REVISED RESPONSE TO REQUEST FOR ADDITIONAL INFORMATION

APR1400 Design Certification

Docket No. 52-046

RAI No.: 13-7856
SRP Section: 12.02 – Radiation Sources
Application Section: 12.2
Date of RAI Issue: 05/22/2015

Table 12.2-25 (3 of 3)

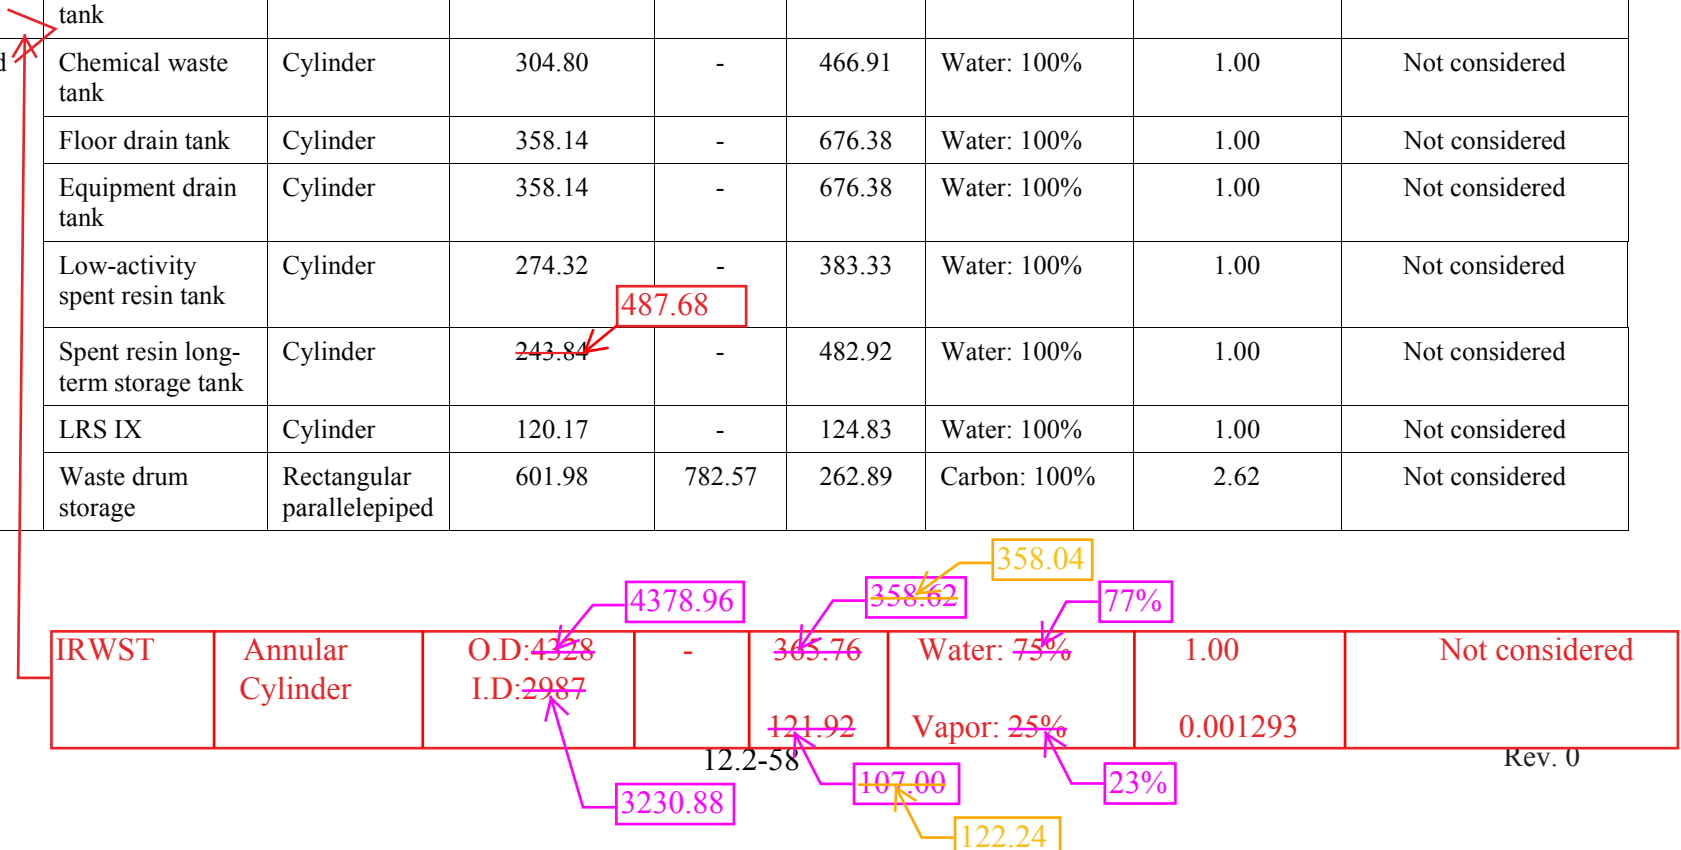
- b. Include the methods, models, and assumptions used in calculating these sources in the FSAR, or provide justification otherwise.
 - c. Include the relevant dimensions and parameters used in the shielding analysis of these sources in FSAR Table 12.2-25.

- b. Update the text of FSAR 12.2 to provide the methods, models, and assumptions used to calculate the VCT source term.
 - c. Ensure that the ratios provided in Table 12.2-25 for the liquid and vapor phases are adequate for the maximum source term.

Tables 1 and 2 of this response provide the liquid and vapor source terms in the pressurizer and IRWST based on 0.25% fuel failure. These source terms will be included in DCD Section 12.2, Tables 12.2-27 and 12.2-13 (5/5) as indicated in Attachment 1.
 - b. The method, models, and assumptions used in calculating these sources will be included in DCD Ch. 12.2.1.1.2 (Pressurizer) and Ch. 12.2.1.1.5.1.d (IRWST) as indicated in Attachment 1.
 - c. Relevant dimensions and parameters used in the shielding analysis of IRWST and pressurizer are shown in Table 3. DCD Table 12.2-25 will be updated to include this information. Additional typographic errors in Table 12.2-25 will also be corrected based

on the staff comments on the response to RAI 8420 Question 12.02-22. Refer to Attachment 2 for the DCD markups.
